Access Compliance Report

Public Rights-of-Way

Intersection ID: 10034533	Main Street: PINEVILLE-MATTHEWS_RD	Cross Street: N/A	Location:	N
ADA ID: 1BBD5713D006	Ramp Type: Perp	Initial Pass/Fail: Fail	Overall Compliance: No	Severity Score: 12.5
Codes/Mitigation Info/Possible Solution		Field Measurements/Component Compliance

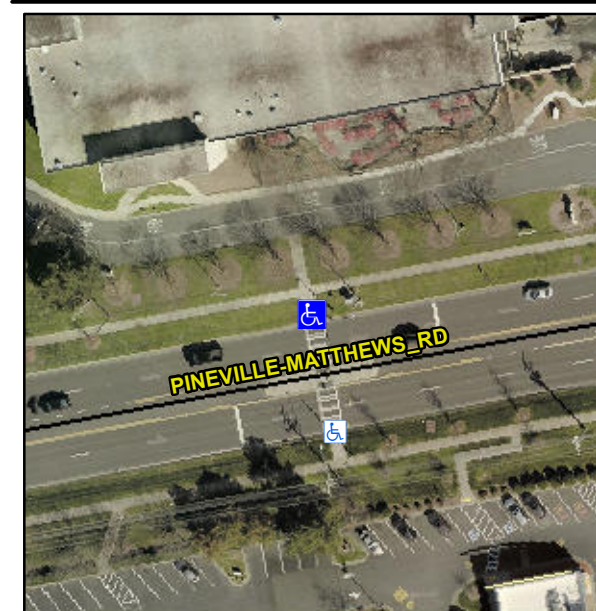
Not Found, R304.2.2

Compliance	Description	Data	Compliance	Description	Data
N/A	Ramp Length (in)	156.0	No	Ramp Slope (%)	9.5
Yes	Ramp Width (in)	71.0	Yes	Ramp XSlope (%)	0.9
N/A	Flare Type LT	N/A	N/A	Flare Type RT	N/A
N/A	Flare Slope LT (%)	N/A	N/A	Flare Slope RT (%)	N/A
N/A	Flare Traversable LT?	N/A	N/A	Flare Traversable RT?	N/A
N/A	Landing Length (in)	N/A	N/A	DWS Provided?	N/A
N/A	Landing Width (in)	N/A	N/A	DWS Contrast?	N/A
N/A	Landing Slope (%)	N/A	N/A	DWS Length (in)	N/A
N/A	Landing X Slope (%)	N/A	N/A	DWS Full Width?	N/A
N/A	Landing Curb? (Y/N)	N/A	N/A	DWS Offset (in)	N/A
N/A	Shared Landing?	N/A			
N/A	Gutter Ponding?	N/A	N/A	Gutter Slope (%)	N/A
N/A	Gutter Lip Ht (in)	N/A	N/A	Gutter X Slope (%)	N/A
N/A	Painted X Walk1?	Yes	N/A	Painted X Walk2?	N/A
	X Walk 1 Direction	To S		X Walk 2 Direction	N/A
N/A	X Walk 1 Width (in)	106.0	N/A	X Walk 2 Width (in)	N/A
	X Walk 1 Slope (%)	2.1		X Walk 2 Slope (%)	N/A
	X Walk 1 X Slope (%)	1.5		X Walk 2 X Slope (%)	N/A

Remove & Replace Entire Ramp.
